Re: Docket ID No. EPA-R08-OAR-2012-0026  
Approval, Disapproval and Promulgation of Implementation Plans; State  
of Wyoming; Regional Haze State Implementation Plan; Federal  
Implementation Plan for Regional Haze" (78 Fed. Reg. 34,738 (June 10,  
2013)

**August 13, 2013**  
**PacifiCorp's "Detailed Comments" regarding:**  
**"Approval, Disapproval and Promulgation of State Implementation**  
**Plans; State of Wyoming; Regional Haze State Implementation Plan;**  
**Federal Implementation Plan for Regional Haze"**

**CHART 1**

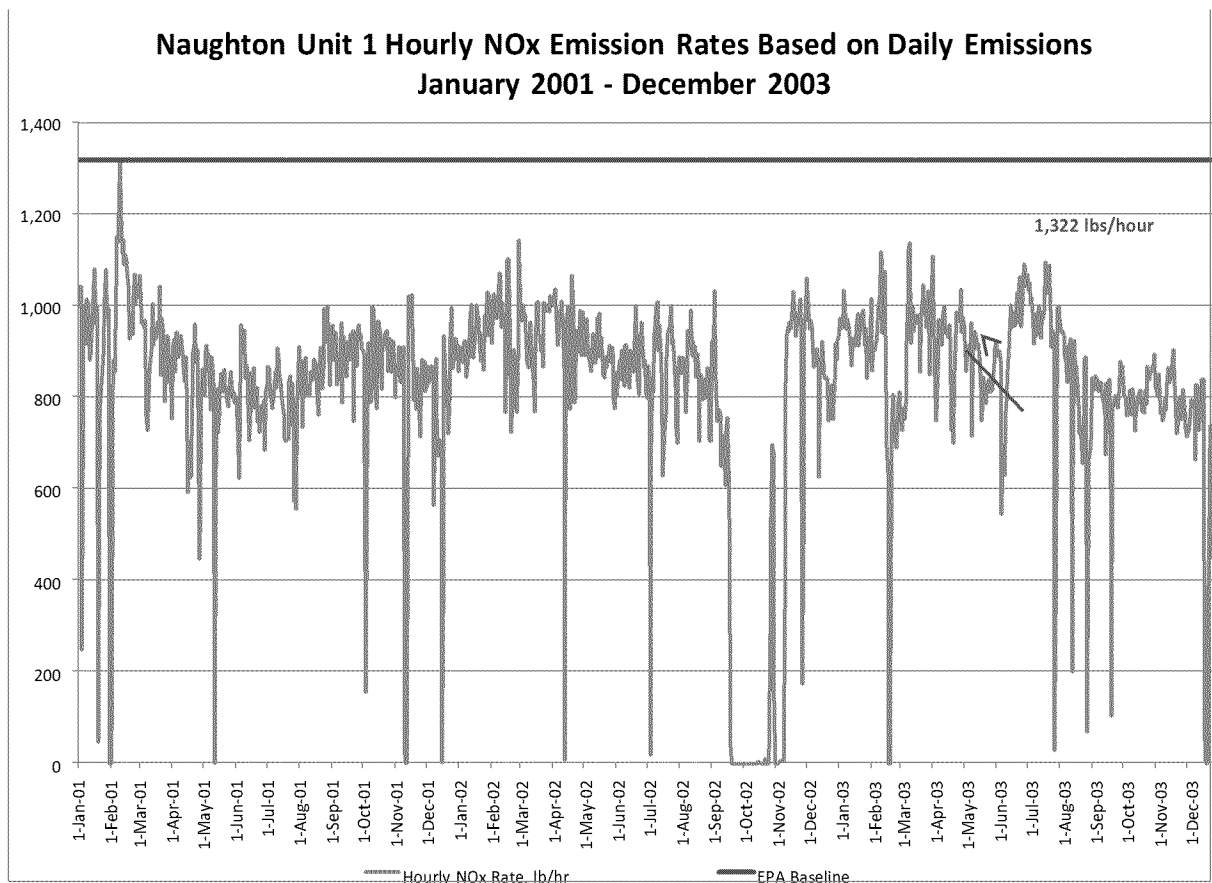
Chart 1, which is specific to Naughton Unit 1, provides a visual comparison of the baseline rate used by EPA to predict the visibility impacts to the actual emissions from this unit over the three-year time period. Noting the significant over-projection of emissions over the entire time period, it is unrealistic to imply that the model can be used to identify the visibility impacts and in turn, the visibility improvements that may reasonably be anticipated. At a minimum, EPA must recognize that CALPUFF's results will over predict improvements and will not lead to results that can be "reasonably anticipated" as compared to actual visibility improvement.
